H2Teesside Project

The H2Teesside Order

Document Reference: 7.3 Change Application Report

Applicant: H2 Teesside Ltd

Figure 2-1: Extract of Site Location Plan Key (original submission) – red indicates Order Limits (Source: Document Ref. 2.1, Rev 0)

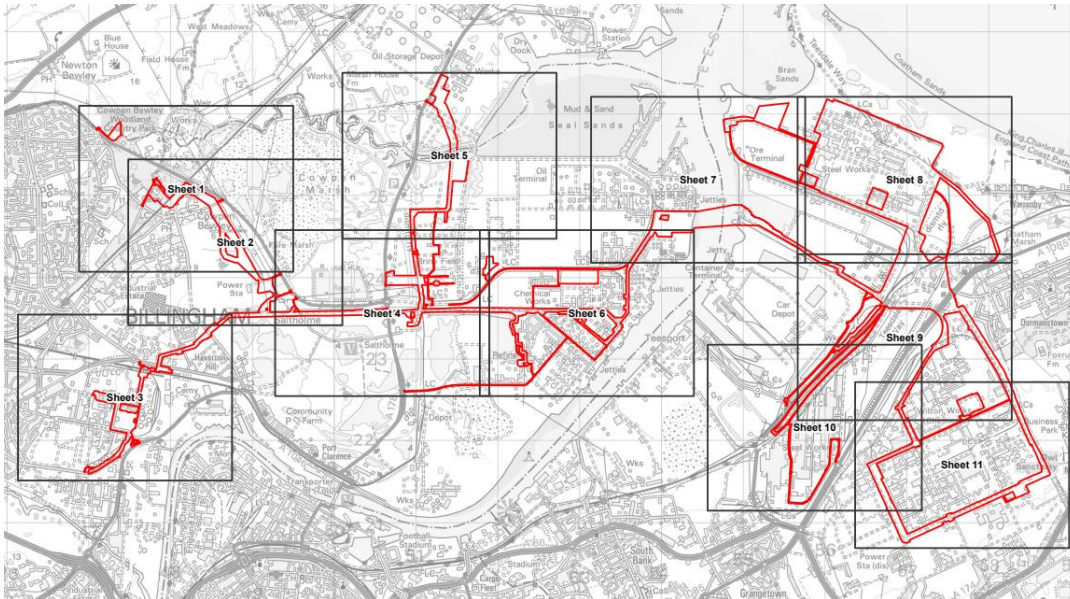
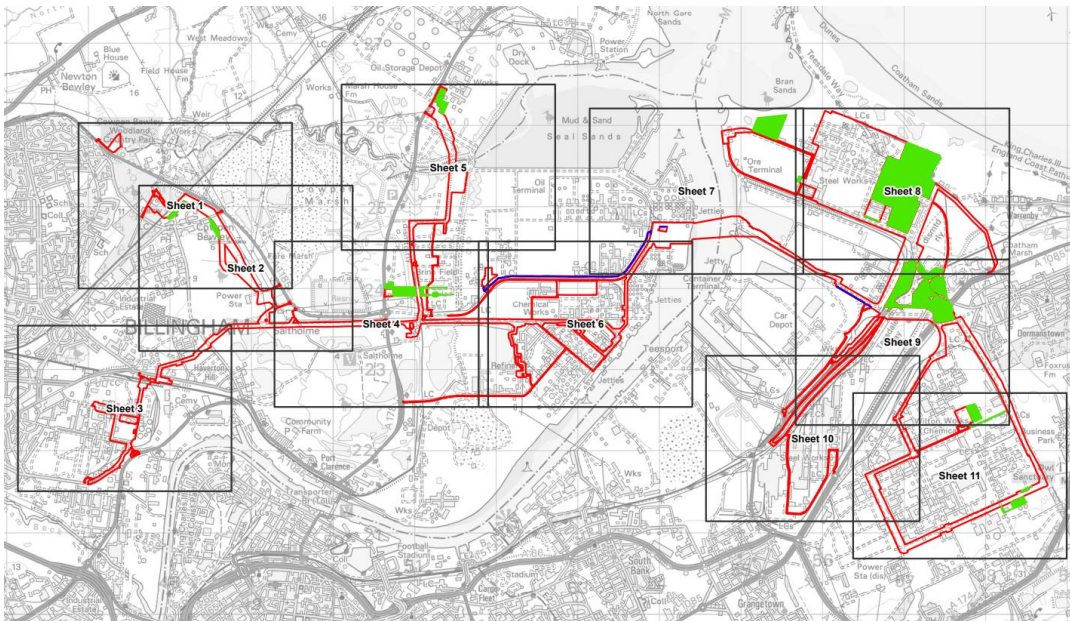
- 2.2.3. For illustrative purposes, screenshots of the key plans for the original Site Location Plan (Document Ref. 2.1, Rev 0) submitted as part of the DCO Application in March 2024, and the key plan in Appendix 1 of the Change Notification [PDA-019] that was submitted on 15 August 2024 are reproduced as Figures 2-1 and Figure 2-2 respectively below.

- 2.2.4. Figure 2-2 shows the land proposed to be removed in green, with the additional land shown in blue.
- 2.2.5. A series of Comparison Plan drawings (Document Ref. 7.8) has also been prepared to illustrate the changes, and these have been referenced below where relevant. Screen shots showing 'before' and 'after' extracts of the Land Plans (Document Ref. 2.2) have also been included where relevant.

Change 1 – Addition of second flare stack for Phase 2 (Work No. 1A.2) – Category ‘A’

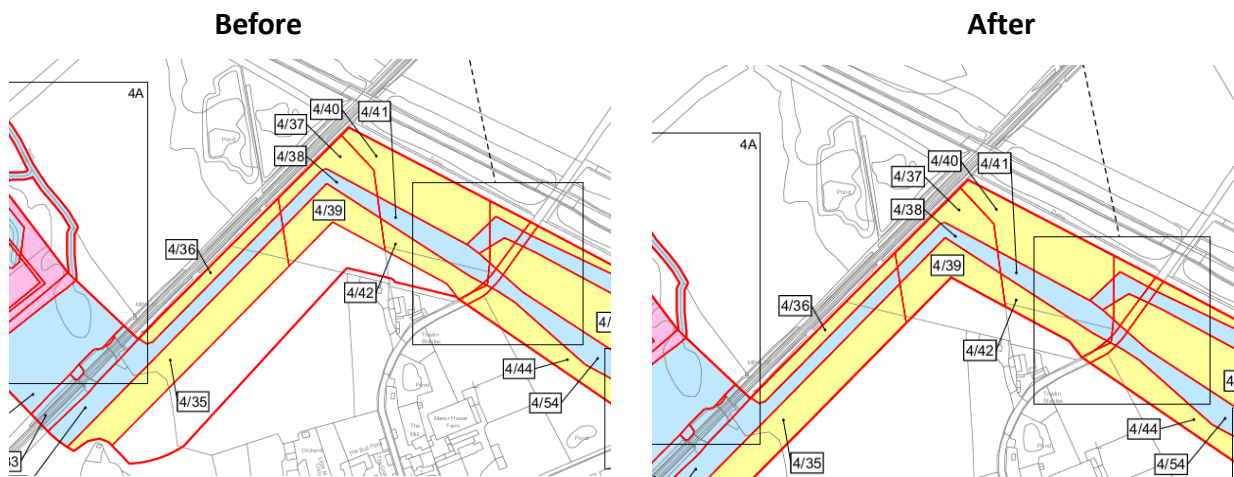
2.3.1. As part of the works for Phase 1 of the Hydrogen Production Facility a flare was proposed within the Main Site (the ‘Phase 1 flare’) (Work No. 1A.1).

-
- 2.3.2. Following the submission of the DCO Application on 25 March 2024, further engineering studies and on site engagement has enabled the design of the Hydrogen Production Facility to be refined. A second flare is now proposed as part of Phase 2 of the Proposed Development. The second flare will also be located within the Main Site (Work No. 1A.2).

- 2.3.3. The second flare will perform the same function as the Phase 1 flare described in ES Chapter 4 ‘Proposed Development’ [APP-056] paragraph 4.3.10, albeit to serve Phase 2 of the Proposed Development only. The second flare will also be designed within the same maximum parameters as the Phase 1 flare, which are presented in ES Chapter 4 Table 4-1 and assessed in the ES, namely a maximum height of 108 m above ordnance datum (‘AOD’) and a minimum height of 73 m AOD, a maximum platform diameter of 4 m and maximum flare stack diameter of 1 m.

Sheet 13 Before

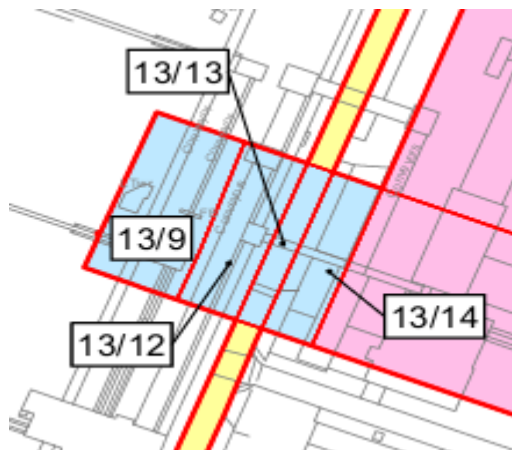
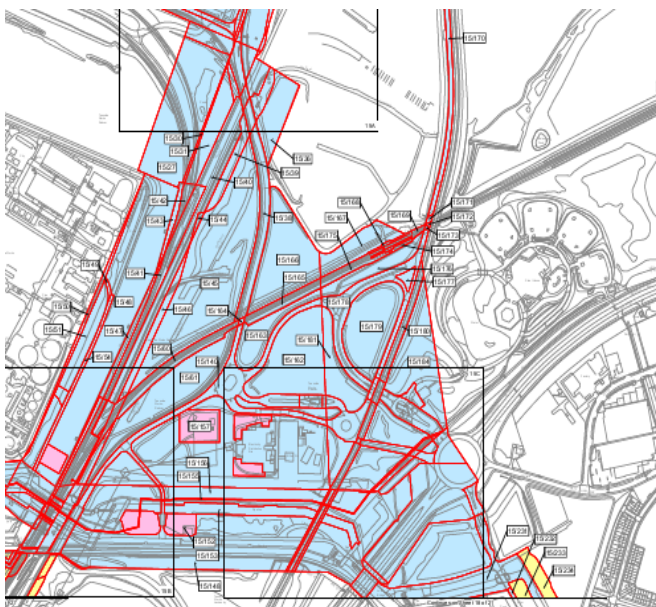
- 2.3.20. The change will result in a reduction of 27.9 ha in the Order Limits. The areas to be removed are indicated by hatching on Figure 4a and Figure 4b of the Comparison Plans (Document Ref. 7.8) and Sheets 13 and 15 of the Land Plans have been amended as shown in the before and after extracts below:

Sheet 15 Before

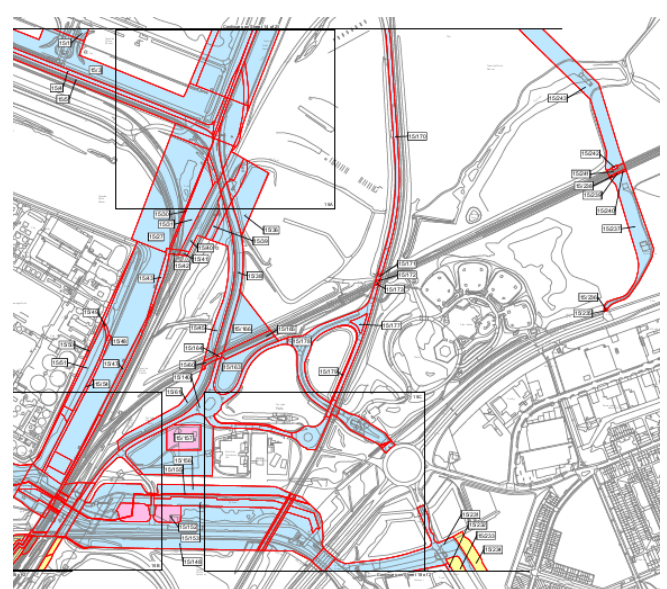
- 2.3.16. This change involves a reduction of the Order Limits in two locations.
- 2.3.17. The first comprises the removal of a parcel of land adjacent to the west of the Main Site (and east of Redcar Bulk Terminal). This will result in a small reduction in the extent of the Hydrogen Distribution Network Pipeline corridor (Work No. 6A.1).

Sheet 19 Before

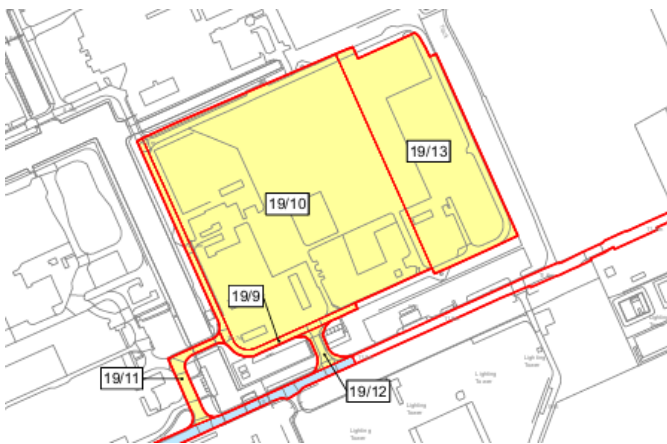
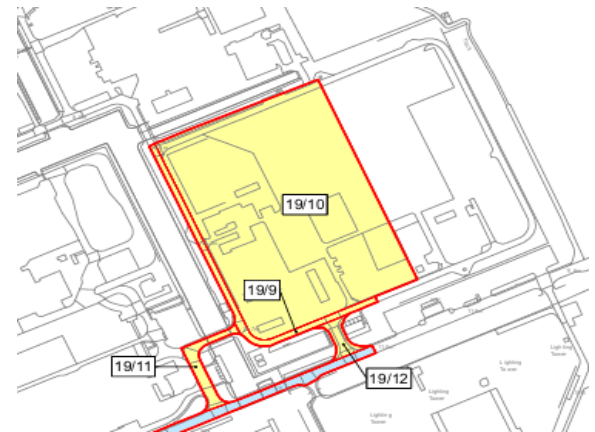
- 2.3.21. This change will reduce the Order Limits at two locations within the Wilton International Site near Lazenby.
- 2.3.22. In the north of the Wilton International Site, two parcels of land will be removed from the Order Limits. The extent of the proposed work area for the Temporary Construction Compound (Work No. 9) will be reduced and part of the internal road will no longer form part of the Order Limits.
- 2.3.23. In the south of the Wilton International Site, two parcels of land will be removed from the Order Limits to the north and south of an internal access road to reduce the extent of the work area for the Hydrogen Distribution Network Pipeline corridor (Work No. 6A.1).

- 2.3.24. These changes are a result of refinement in construction methodology following discussions with relevant stakeholders including Anglo American.
- 2.3.25. The change will result in a reduction of 4.9 ha in the Order Limits. The areas to be removed are indicated by hatching on Figure 5 of the Comparison Plans (Document Ref. 7.8) and Sheets 19 and 20 of the Land Plans have been amended as shown in the before and after extracts below:

Change 2.F - Removal of Northern Gas Networks AGI off the A178 Seaton Carew Road (Work No. 6A.3) – Category ‘C’

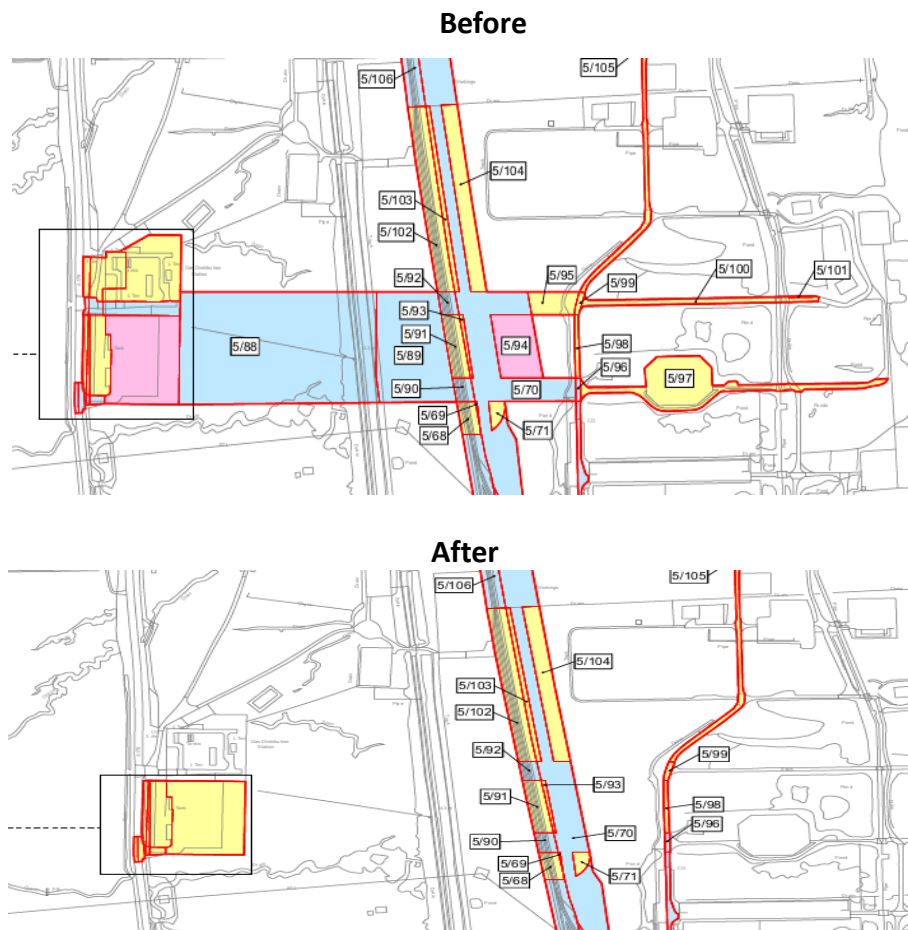
- 2.3.26. Three options were included in the DCO Application for connection into gas networks to facilitate blending of hydrogen with natural gas and connection to Project Union. These are (1) the National Gas Grid AGI near Billingham; (2) the Northern Gas Network natural gas AGI at Cowpen Bewley; and (3) the Northern Gas Networks AGI off the A178 Seaton Carew Road.
- 2.3.27. Further engineering and commercial work with Northern Gas Networks has resulted in the conclusion that the Northern Gas Networks AGI is not technically or commercially suitable for blending meaningful volumes of hydrogen into the gas network nor a connection to Project Union and as result the AGI for connection into Northern Gas Networks pipeline off the A178 Seaton Carew Road is proposed to be removed from the DCO Application.

- 2.3.28. Also, as a result of this change, horizontal directional drilling ('HDD') adjacent to the Teessmouth and Cleveland Coast Special Protection Area ('SPA') to reach the new AGI is no longer required at this location.
- 2.3.29. The change will result in a reduction of 5.3 ha in the Order Limits. The area to be removed is indicated by hatching on Figure 6 of the Comparison Plans (Document Ref. 7.8) and Sheet 5 of the Land Plans has been amended as shown in the before and after extracts below:

Change 4 – Addition of temporary construction compound on land at Navigator Terminals (Work No. 9) – Category ‘B’

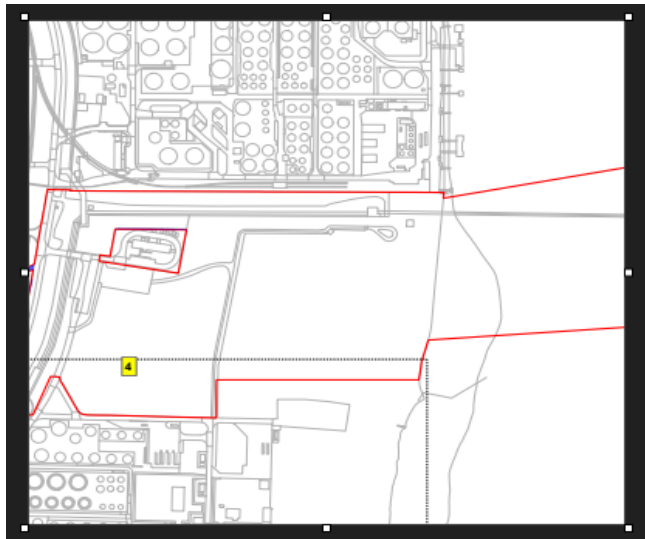
- 2.3.32. A new temporary construction compound is proposed on land owned by Navigator Terminals to be added to the Proposed Development as part of Work No. 9. This will be located in Plot 11/24 shown on the Land Plans, Sheet 11 [APP-008]. This land is located on the north bank of the River Tees and will primarily act as a Temporary Construction Compound to support HDD works for Work No. 6A.2 underneath the Tees. This change does not require any changes to the Order Limits.

- 2.3.34. The proposed change will not alter the Order Limits and only affects Plot 11/24 (which was already in the Order limits for temporary purposes). It is shown indicatively below:
